January 13, 2022

Re: **PETITION NO. 1464** - The Connecticut Light and Power Company d/b/a Eversource Energy petition for a declaratory ruling, pursuant to Connecticut General Statutes §4-176 and § 16-S0k, for the proposed Rockville Upgrade Project consisting of the replacement and reconductoring of electric transmission line structures along approximately 1.2 miles of its existing No. 1606 and No. 1724 115-kilovolt transmission lines within existing Eversource electric transmission line right-of-way between Rockville Junction and Rockville Substation in Vernon, Connecticut, and related electric transmission line and substation improvements. - Amendment

Attachment: Updated Map-Sheet 2

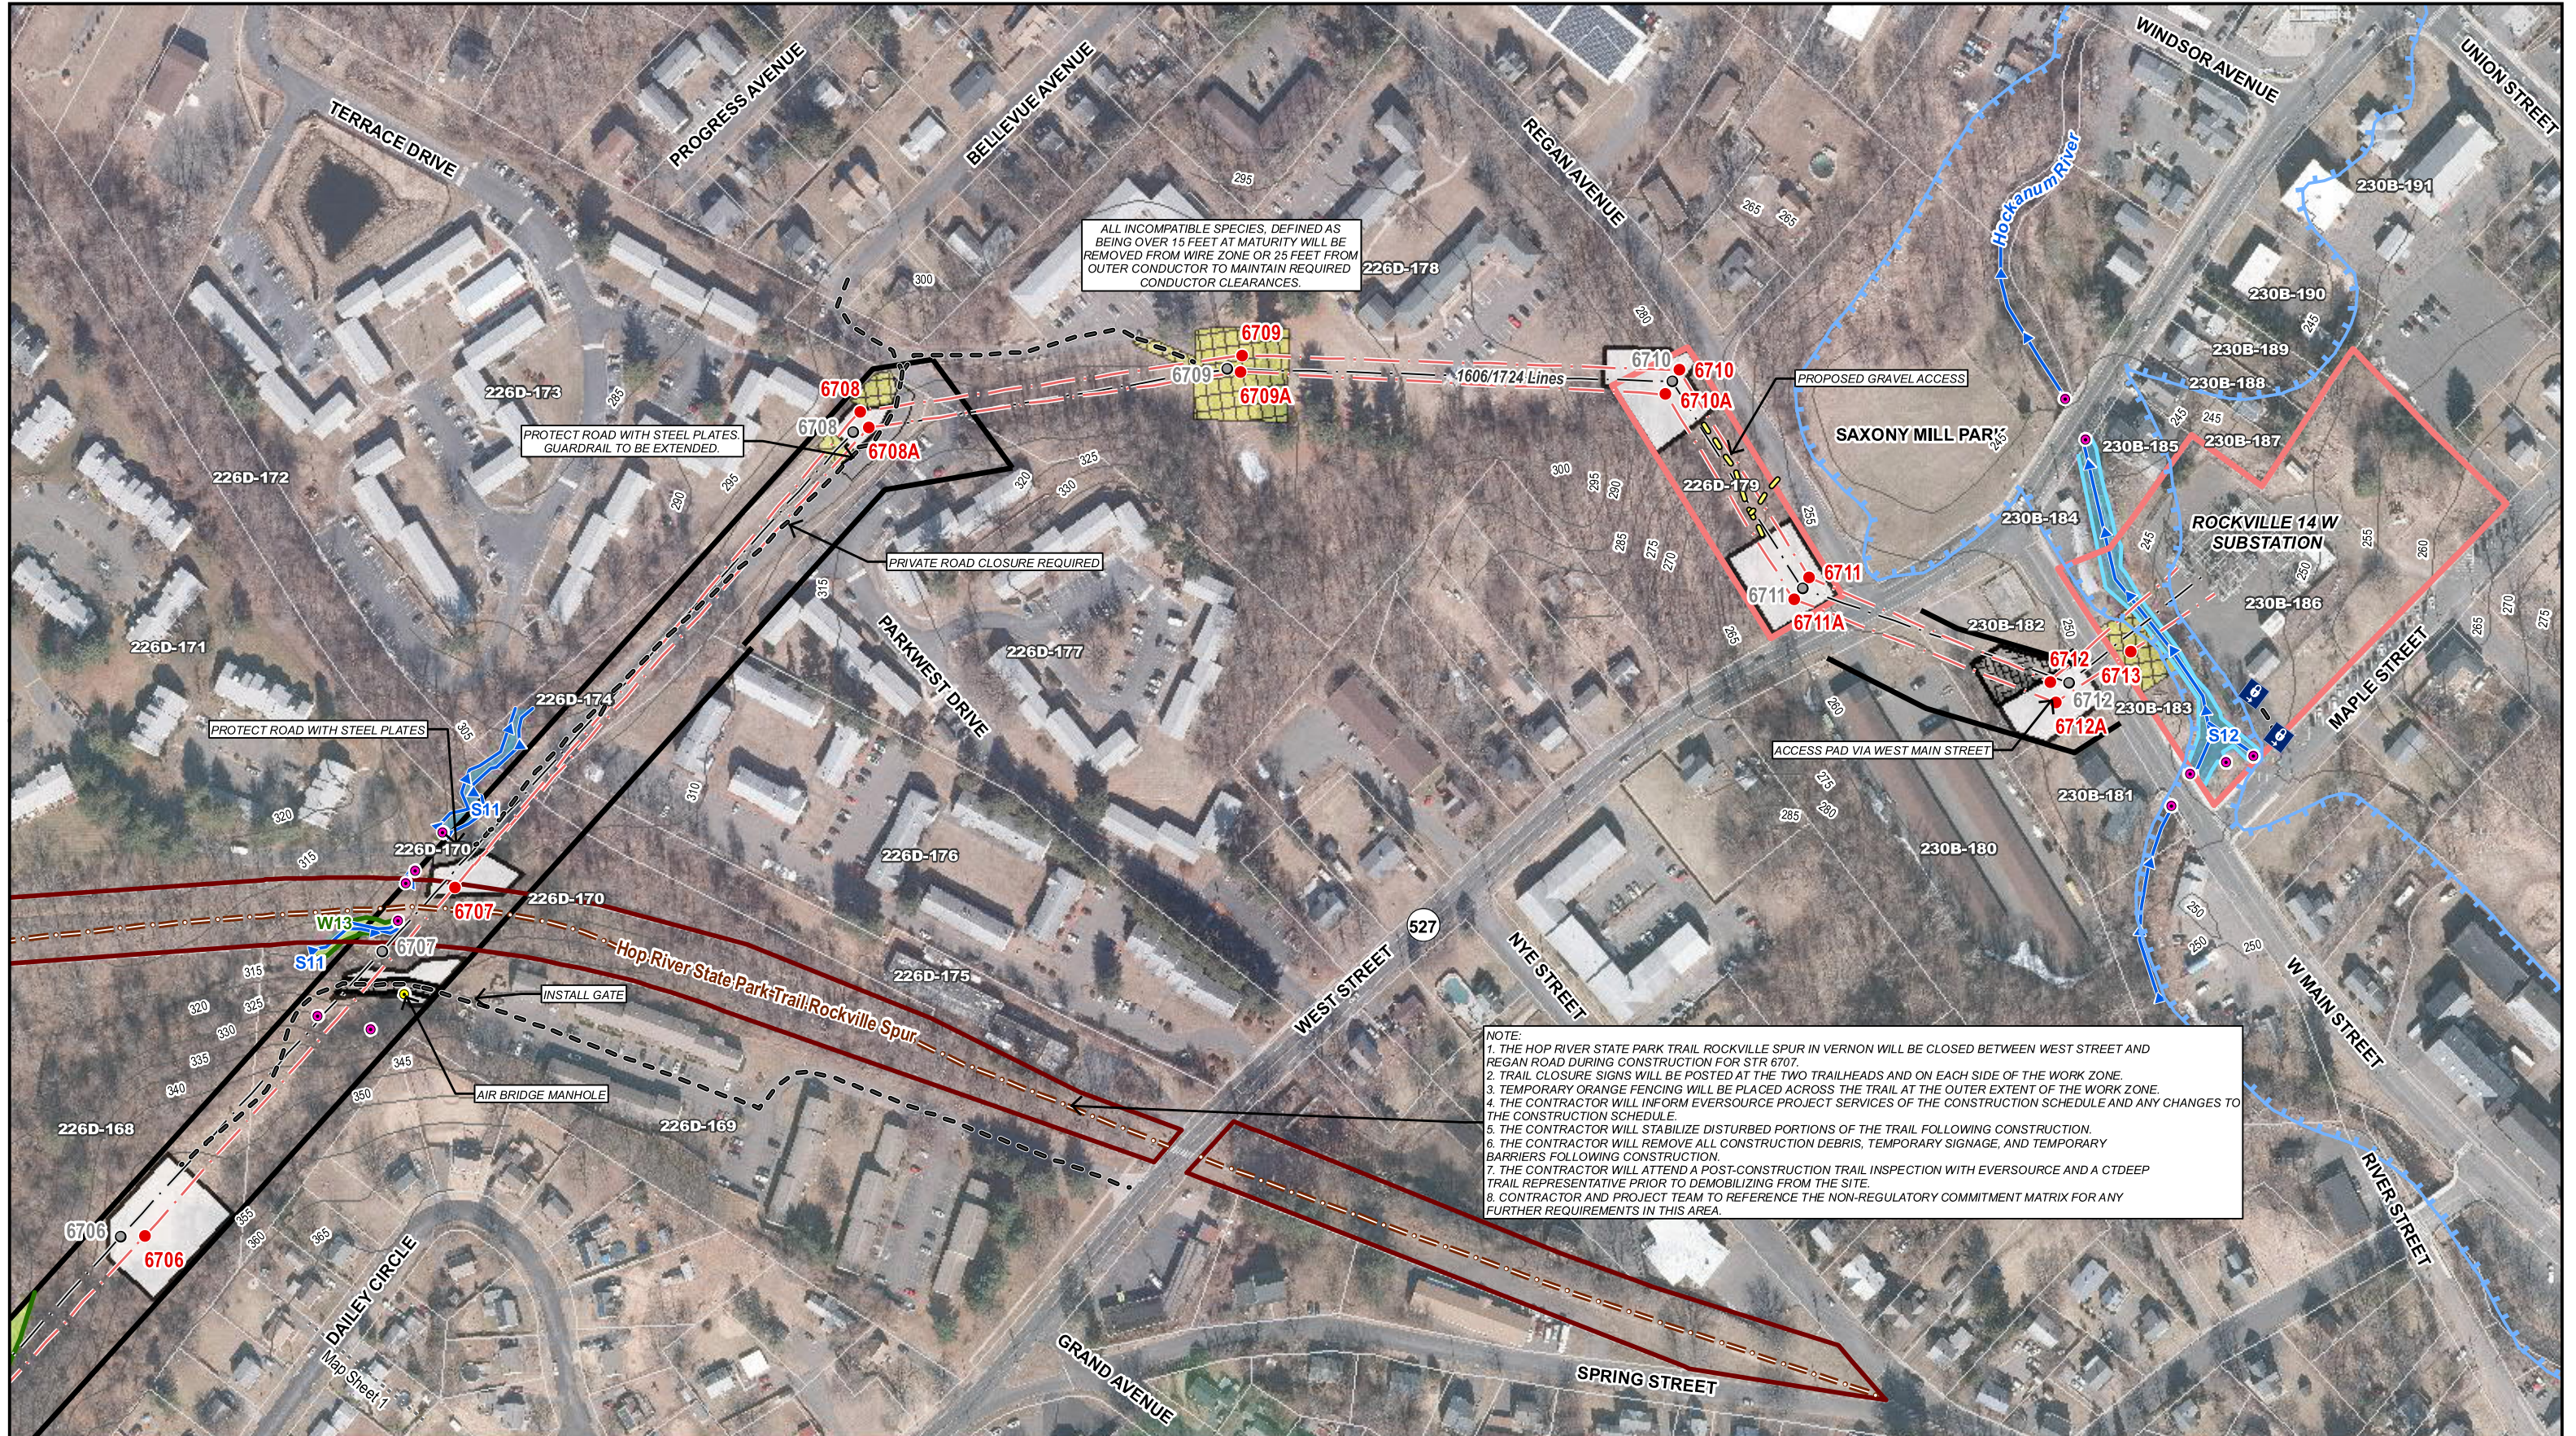
A pre-construction soil boring discovered that the structure would impact a previously unknown brick sewer line that traverses the site and appears to be still in use. Eversource Real Estate is following up as to the owner and status of the sewer line.

As a result of this discovery, Eversource is shifting the location for the proposed structure closer to West Main Street and approximately twenty feet east off the edge of the streambank as depicted in the Attachment, Updated Map-Sheet 2.

1	12/2/21	Structure 6713 relocated to updated position	AM	CM	KvN	ES
<b>EVERSOURCE ENERGY</b>						
<b>Rockville Upgrade Project</b>						
Vernon, CT				<b>MAP SHEET 2 OF 2</b>		
Date: December 02, 2021						
<b>AECOM</b>						
NO.	DATE	REVISIONS	BY	CHK	APP	APP
